REQUEST FOR ADDITIONAL INFORMATION CENTRAL PARK CONCEPT PLAN MP 06_0171 - MODIFICATION 13

This letter has been prepared by Ethos Urban on behalf of Frasers Property in response to the request for additional information made by the Department of Planning and Environment (the Department) via email on 21 February 2018 and subsequent meeting on 14 March 2018, in relation to the proposed section 75W modification to the Central Park Concept Plan (MP 06_0171). This letter provides an amended description of the modifications and proposed conditions, and is supported by the following additional information:

Figure 1 Approved and proposed Public Domain Plan (A-1254)

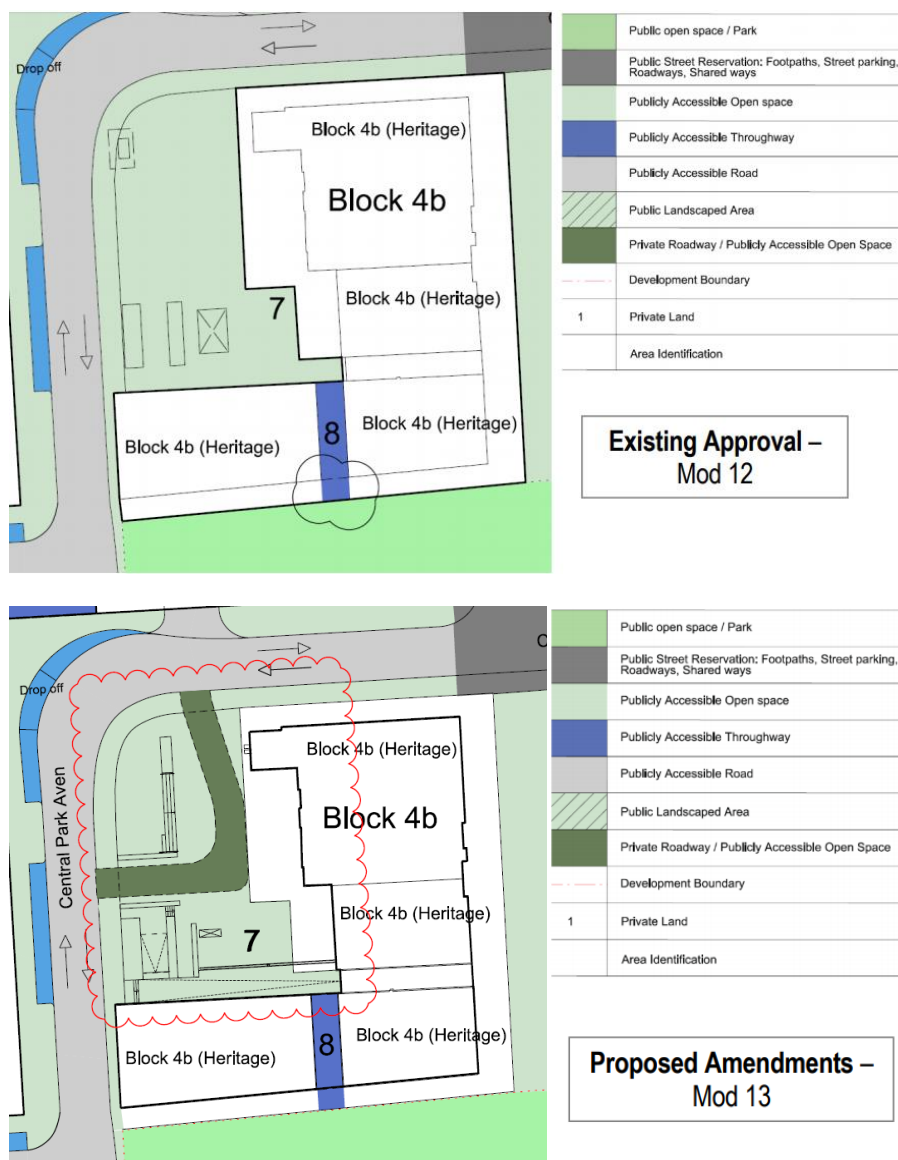
This section 75W modification relates to amendments to the Public Domain Plan (A-1254) of the Central Park Concept Plan to allow for vehicle access within the publicly accessible private open space of Site 7 and minor changes to the delineation of Block 4B and Site 7. The purpose of providing vehicle access within this area is to:

Public Domain Plan (A-1254) (**Attachment A**) is proposed to be modified to demarcate the area in which a future driveway access is to be located. The area, similar to other areas within the Central Park Concept Plan providing driveway access over publicly accessible open space, will be classified as 'Private Roadway/Publicly Accessible Open Space' (refer to **Figure 1**). This is consistent with the distinction of the driveway access to Block 11 which maintains pedestrian connection through the Block 11 site.

The proposed access is to be restricted to vehicles 6.4m or less and restricted to the hours of 7.00am-10.00am and 2.00pm-5.00pm. In cases of commercial/retail tenancy fit outs or major equipment replacement from the CTP such restriction would be waived and the area temporarily closed for safety reasons. Given the infrequent usage (a 2-3 day period every 5-10 years), 7 day's notice would be required unless for emergency work.
